Subject: Los Osos/Baywood Park Nitrogen Study

At the request of the staff of the Central Coastal Regional Water Quality Control Board I have completed an independent review of the Los Osos/Baywood Park Nitrogen Study, dated July 1994. I have also toured the study area and viewed the individual monitoring sites. I have worked in the field of on-site sewage disposal for the past 20 years, including considerable study of nitrate and other cumulative impact issues. A copy of my curriculum vitae is attached summarizing my educational background and experience. This letter summarizes my review comments.

FIGURE 27

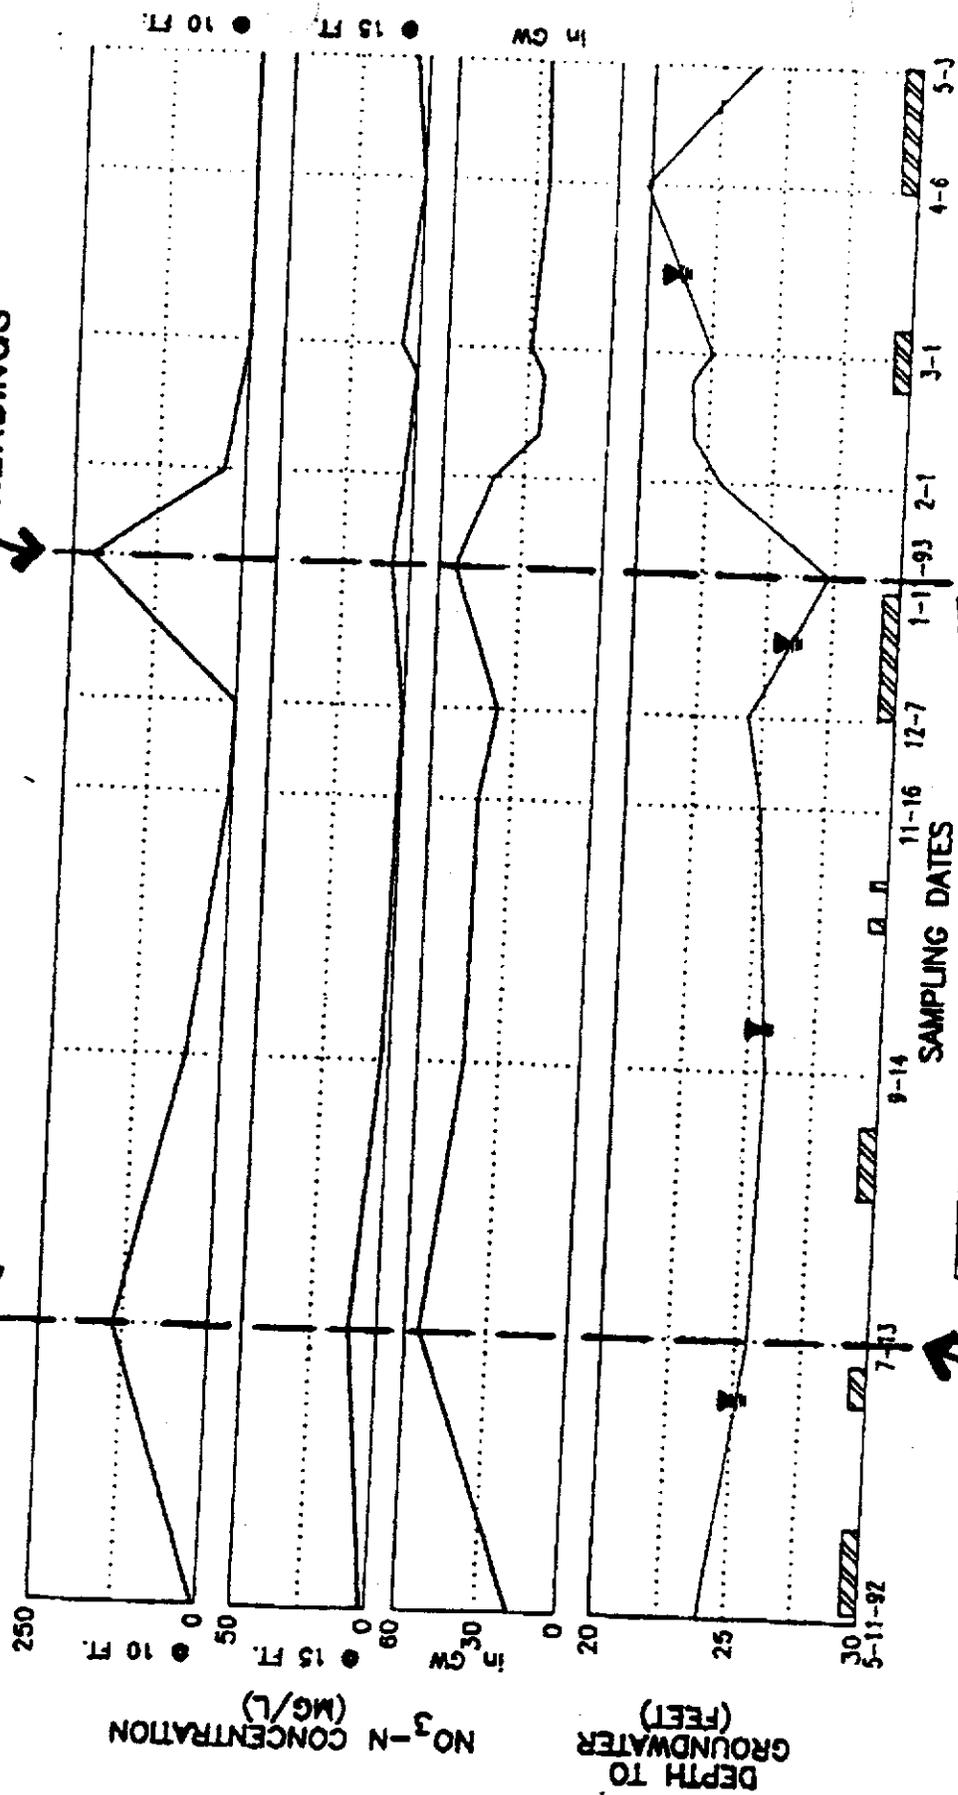
2. **Nitrate Correspondence with Water Table Level.** The TAC study places strong emphasis on the apparent correspondence of the highest nitrate groundwater readings with the lowest water table conditions (i.e., when the leachfield is not in operation). This is cited as evidence that off-site sources, and not the leachfield system, are the cause of the high nitrate concentrations in groundwater.

A careful review of the data, as presented in Figure 27 (attached) in the report, discounts this interpretation by the TAC. What Figure 27 shows is that the peak groundwater nitrate concentrations coincide with the start-up of leachfield operation after a period of resting. These peak groundwater concentrations also correspond with peak readings in the 10-foot and 15-foot lysimeters; inclusion of TKN values would make the lysimeter total nitrogen readings even more pronounced.

The spike in the nitrate readings upon leachfield start-up is consistent with the seasonal flushing of pollutant build-up in the soil that is often seen in groundwater data. In this case, the resting period allows the residual nitrogen from the wastewater to be completely nitrified, and subsequently mobilized and carried into the groundwater with re-initiation of the leachfield discharge. The interpretation and conclusion of the TAC regarding influx
